**CULTURAL RESOURCES OFFICE
PRESERVATION BOARD
REGULAR MEETING
MONDAY MARCH 23RD, 2009
1015 LOCUST ST. #1200
4:00 P.M.**

Date: March 23, 2009
To: City of St. Louis Preservation Board
From: Jan Cameron, Cultural Resources Office
Subject: Preliminary Review: Construct 2-story addition; detached “carriage house,” and two 2-car garages in side yard of 2-story single-family house in the Lafayette Square historic district
Address: 1824 Kennett Place
District: Lafayette Square Historic District **Ward: 6**

DATE: March 23, 2009
SUBJECT: Preliminary Review for new construction of health center
ADDRESS: 4414 N. Florissant Avenue
JURISDICTION: Hyde Park Certified Local Historic District - Ward 3
FROM: Andrea Gagen, Preservation Planner, Cultural Resources Office

DATE: March 23, 2009
SUBJECT: Appeal of staff denial to construct a roof deck
ADDRESS: 2014 Rutger
JURISDICTION: Lafayette Square Local Historic District - Ward 6
FROM: Andrea Gagen, Preservation Planner, Cultural Resources Office

WEST ELEVATION OF 1824 — ADDITION TO BE ATTACHED BEHIND PROJECTING BAY

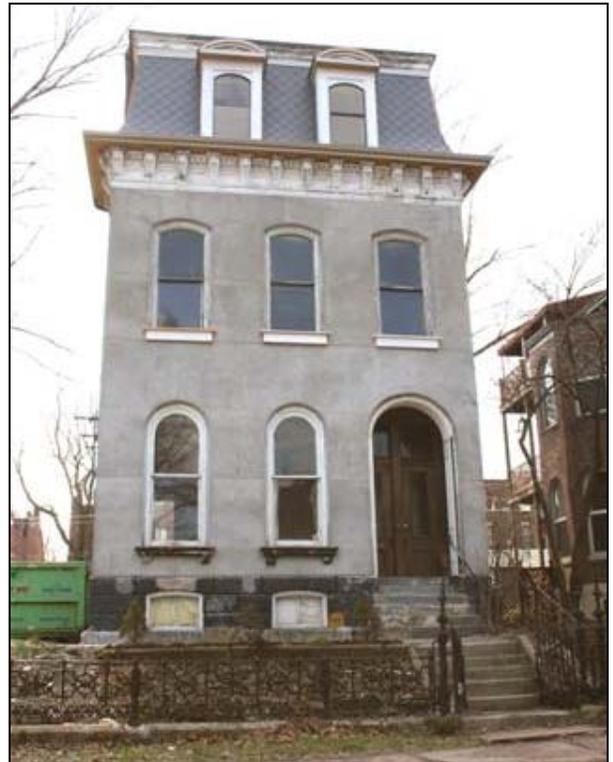
Complies. The proposed addition will be made to the rear of the west elevation, which is an Intermediate Façade.

HISTORIC STONE RETAINING WALL AND WROUGHT-IRON FENCE

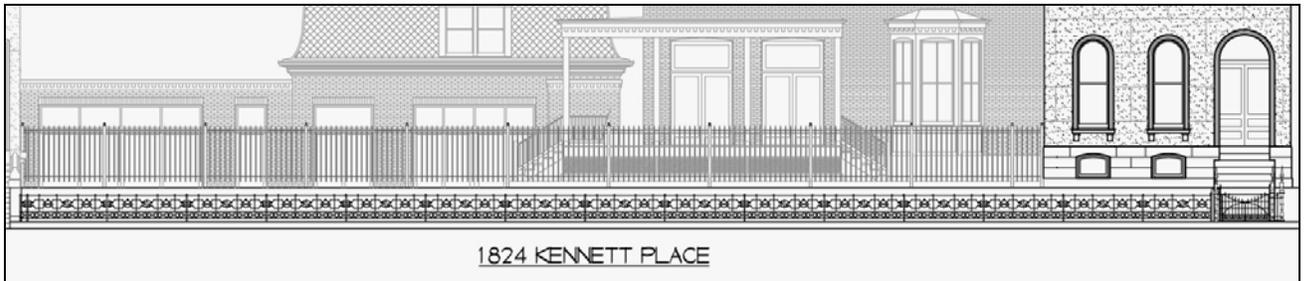
Low fence complies. The existing historic wrought-iron fence in front of 1824 Kennett will be replicated across all parcels.

High fence does not comply. A 6-foot high wrought-iron fence is proposed to be installed atop the terrace, and approximately 6 feet in front of the building line.

1. That the proposed wrought-iron high fence be eliminated or moved to 12 inches behind the building line;
2. that the applicant work with the staff to finalize design details; and
3. that full architectural drawings are submitted for final staff review.

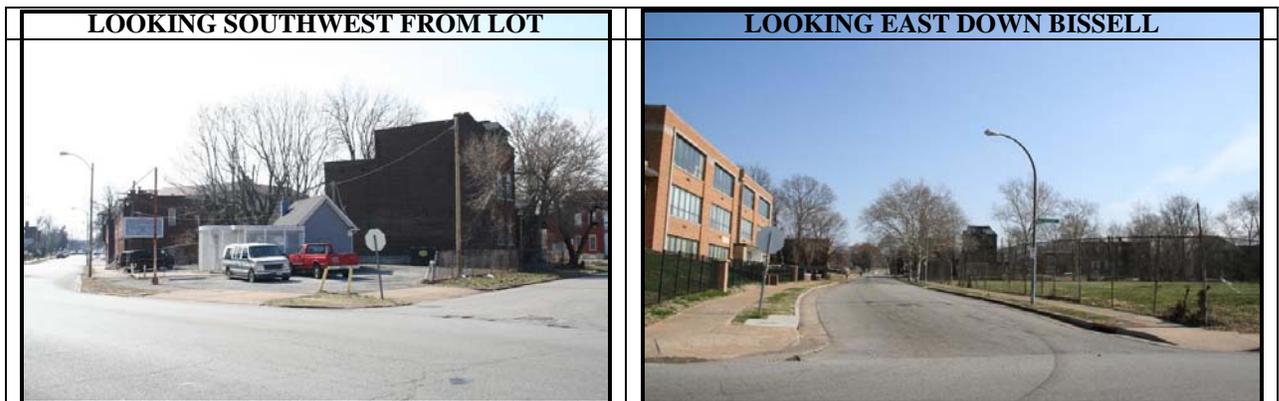
Does not comply. The signs are above the point of where the second floor window sill would be located.

Does not comply. The projecting sign is above the point of where the second floor window sill would be located.

LOCATION OF PROPOSED ROOFTOP DECK FROM REAR

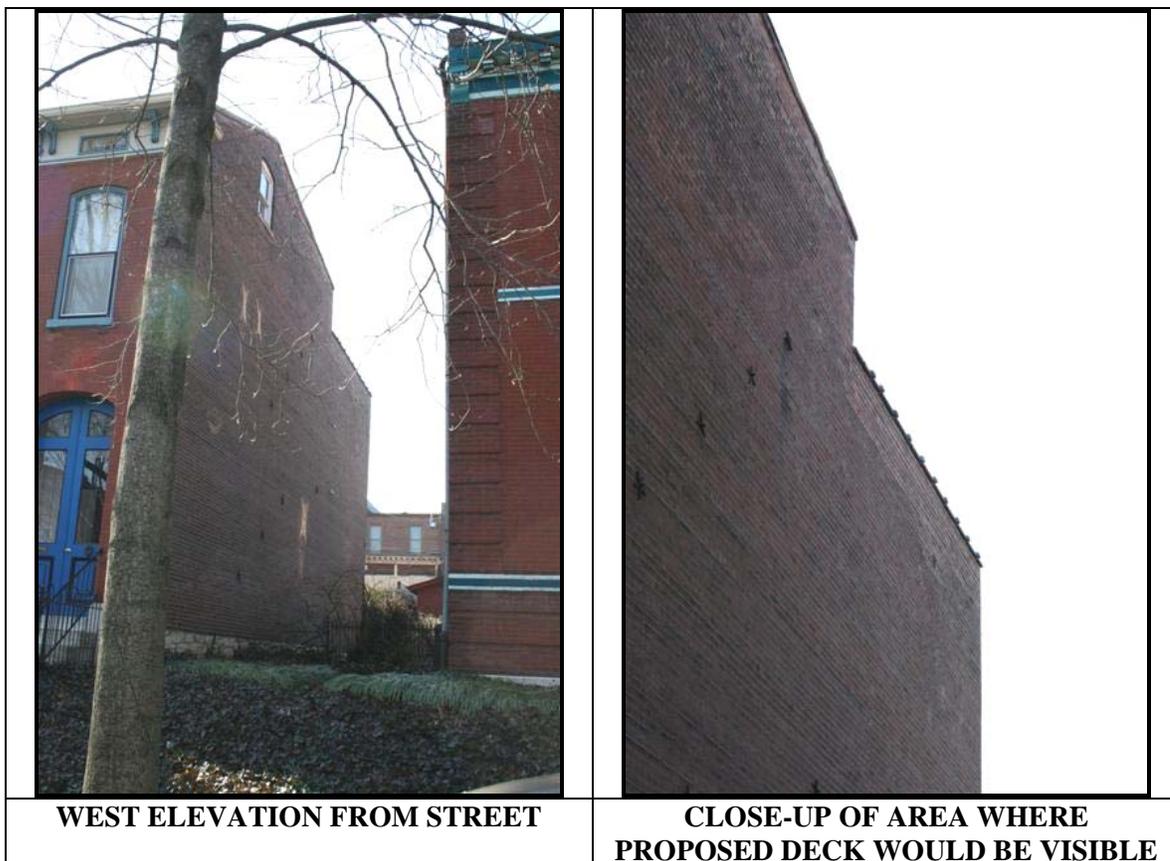
The owner has applied for a roof deck at the rear of 2014 Rutger. Due to the drop in height of the roof, the deck's relationship to the parapet wall, and the distance between the houses on the

west side, the Cultural Resources Office has determined that the handrail on that elevation will be highly visible from the street. The Cultural Resources office asked the owner to lower the height of the handrail and move it 3' to the east, in line with the edge of the walkway. The owner has agreed to lower the height of the handrail, but does not wish to move it to the east. The Cultural Resources Office believes that the roof deck in that configuration does not meet the Lafayette Square Historic District standards due to its visibility from the street.

The Cultural Resources Office is asking that the Preservation Board deny the roof deck as it does not meet the Lafayette Square Historic District standards.
